Re: ***Addendum No. 1***
Minford Area Water Storage Tank
Scioto County Regional Water District No. 1

Date: February 6, 2024

1. SHEET 01C-02 – WATER STORAGE TANK PLAN & SECTION

PROJECT NO.	220898
DISCIPLINE	CIVIL
SHEET NAME	01C-02
SHEET	4
OF	8

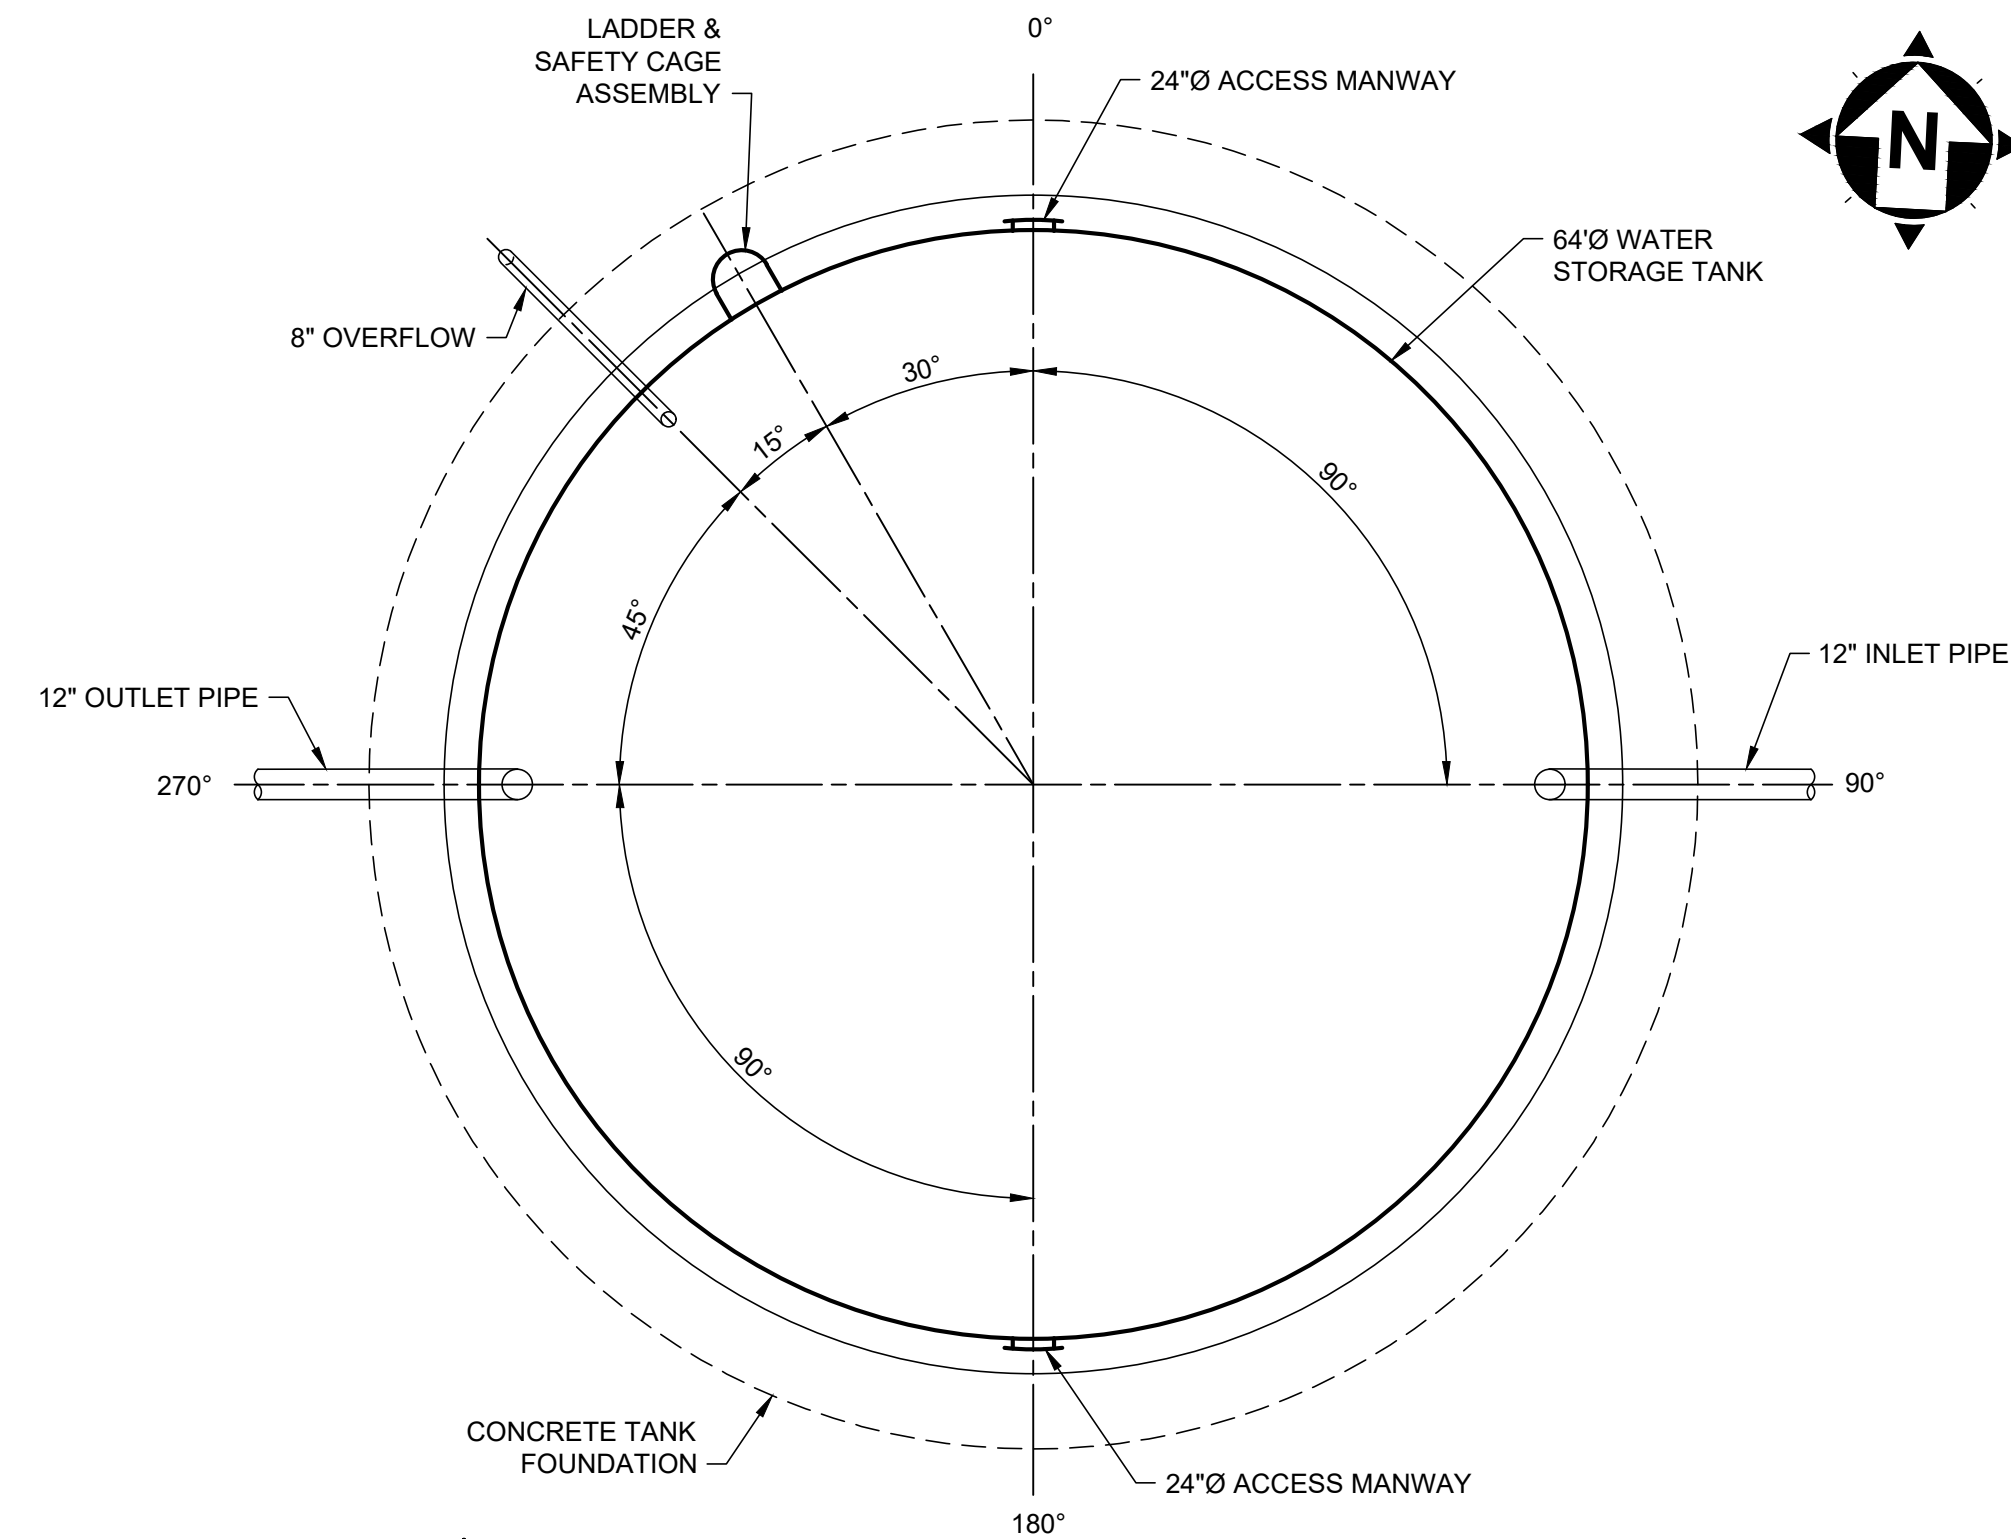
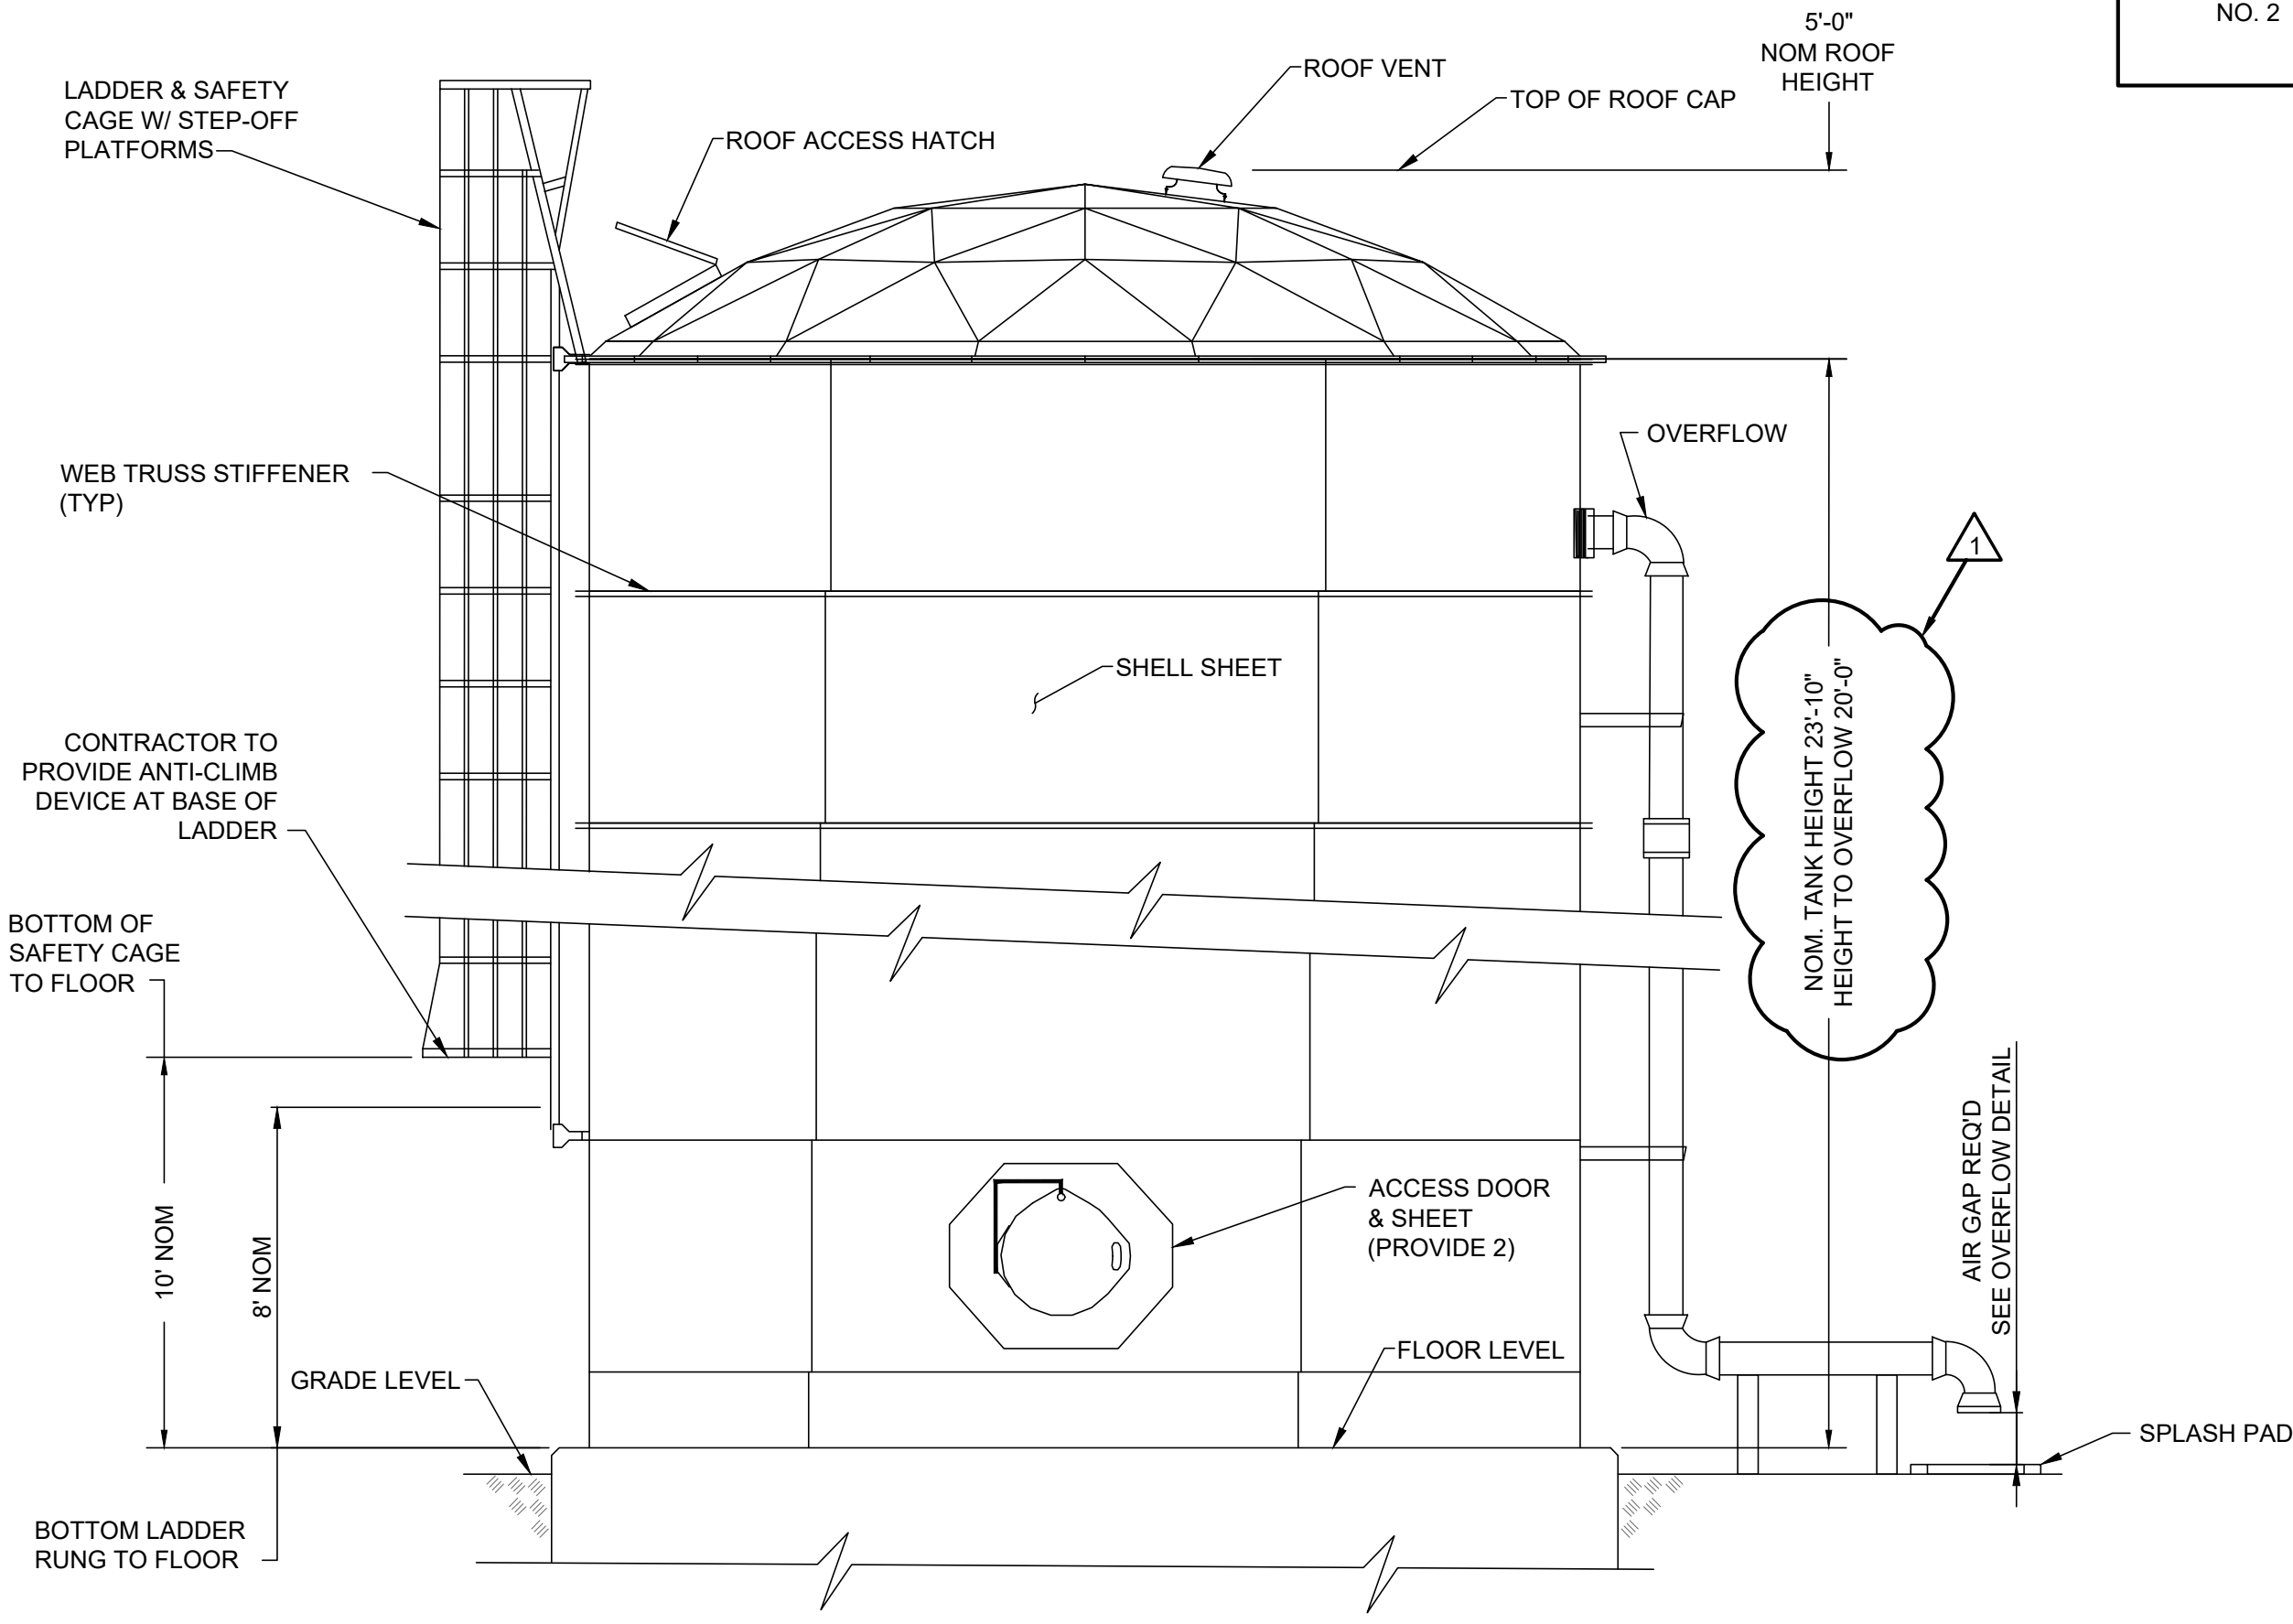
- a. **REPLACE** this drawing in its entirety with the revised drawing attached to this addendum.
